DOMINION ENERGY KEWAUNEE, INC.
KEWAUNEE POWER STATION
RESPONSE TO REQUEST FOR ADDITIONAL INFORMATION:
LICENSE AMENDMENT REQUEST 244, PROPOSED REVISION TO
RADIOLOGICAL ACCIDENT ANALYSIS AND CONTROL ROOM ENVELOPE
HABITABILITY TECHNICAL SPECIFICATIONS (TAC NO. ME7110)

**RESPONSE TO REQUEST FOR ADDITIONAL INFORMATION:
LICENSE AMENDMENT REQUEST 244, PROPOSED REVISION TO
RADIOLOGICAL ACCIDENT ANALYSIS AND CONTROL ROOM ENVELOPE
HABITABILITY TECHNICAL SPECIFICATIONS**

ME7110-RAII-AADB-Brown-005-2012-05-13

Figure 3.1-1 Kewaunee Source and Receptor Points

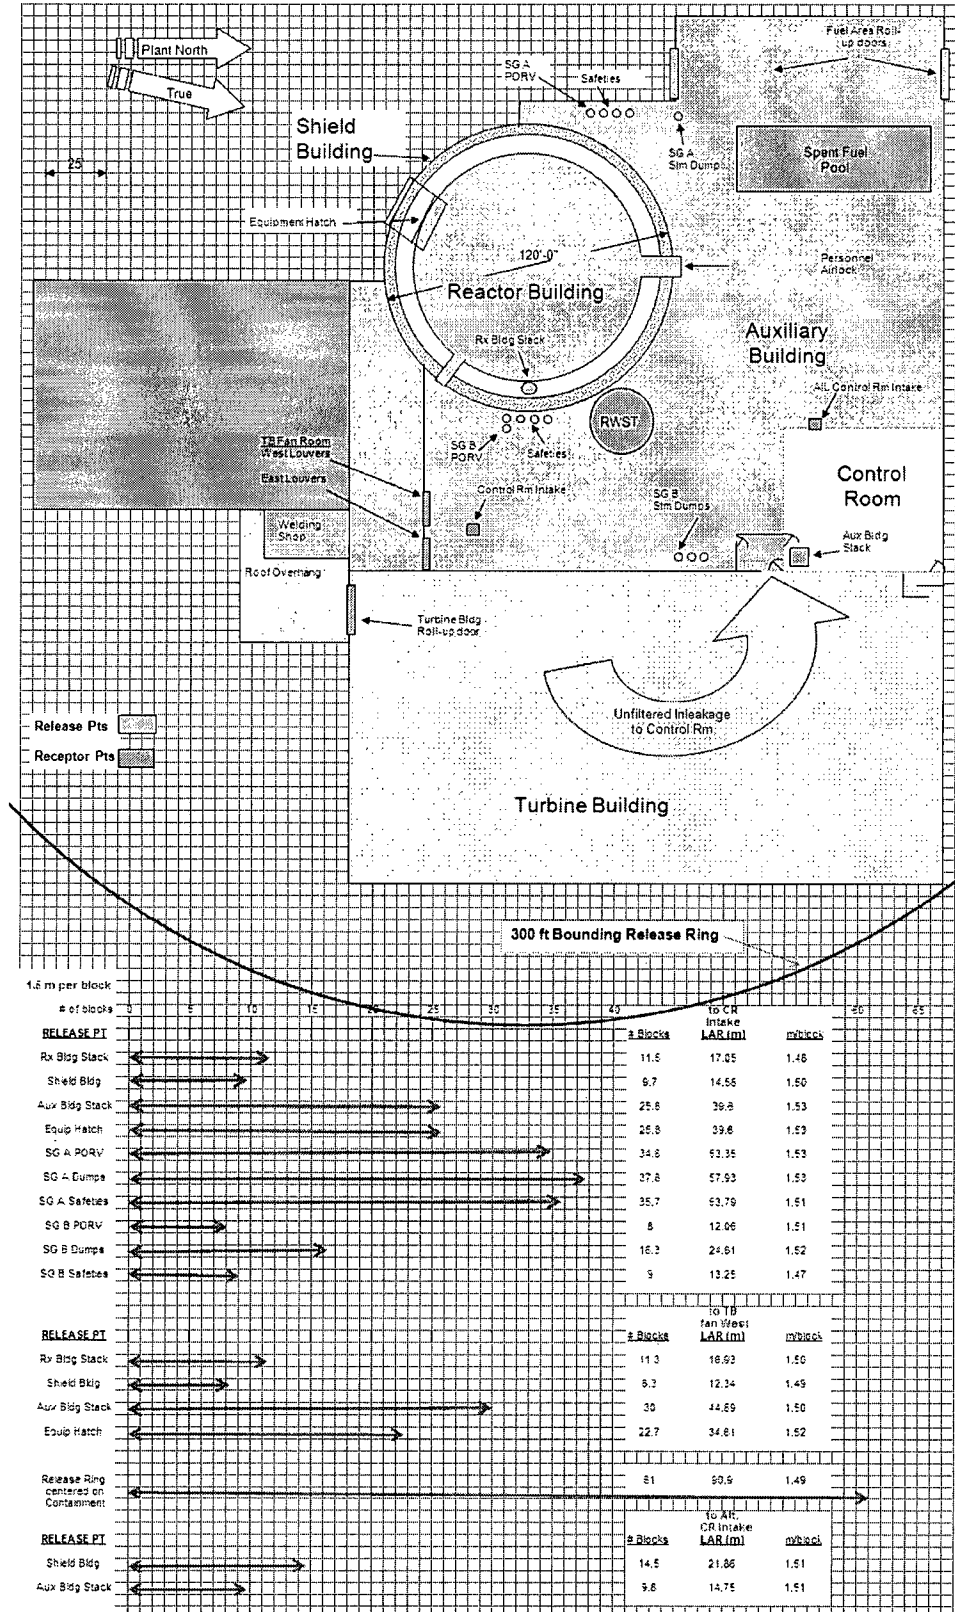
The LAR states that Figure 3.1-1, "Kewaunee Source and Receptor Points," of Attachment 4 provides a relative scaled drawing of the Kewaunee Power Station building orientation and control room location showing all identified release points and receptors. The figure is very informative, but does not appear to be drawn entirely to scale and/or to have all sources and receptors positioned on the figure based upon the scale. For example, Table 3.1-1, "Line-of Sight Horizontal Distance from Source to Receptor," of Attachment 4, lists the distances from the "SG [steam generator] B PORV [power operated relief valve]" and "SG B Dumps" to the Control Room Intake as 12.06 meters (m) and 24.81 m, respectively. However, in Figure 3.1-1, the SG B Dumps appear to be slightly closer to the Control Room Intake than the SG B PORV. Please revise Figure 3.1-1 to provide the scaled position of each source and receptor, as appropriate, to confirm the information provided in Table 3.1-1 and Table 3.1-2, "Direction from Receptor to Source," of Attachment 4.

- a. With regard to Figure 3.1-1, where is the alternative CR intake?
- b. Describe the conditions under which its use is permitted.
- c. Provide the inputs to the CR atmospheric dispersion factor (X/Q value) estimates for each design basis accident which could occur when the alternative CR intake is in use.

Figure 3.1-1 was revised and scaled to more accurately identify the physical orientation of release points and receptors. The revised Figure 3.1-1 is provided below.

- a. Figure 3.1-1 was revised to include the identification where the alternative CR intake is located. See response to Question 5 above.
- b. There is no longer any condition for which the alternate control room intake will be used and administrative controls will be in place to prohibit the use of the alternative CR intake and applicable procedures will be revised accordingly. For additional information regarding maintaining the alternate CR intake closed at all times see DEK response to Question 9 in Reference 4.
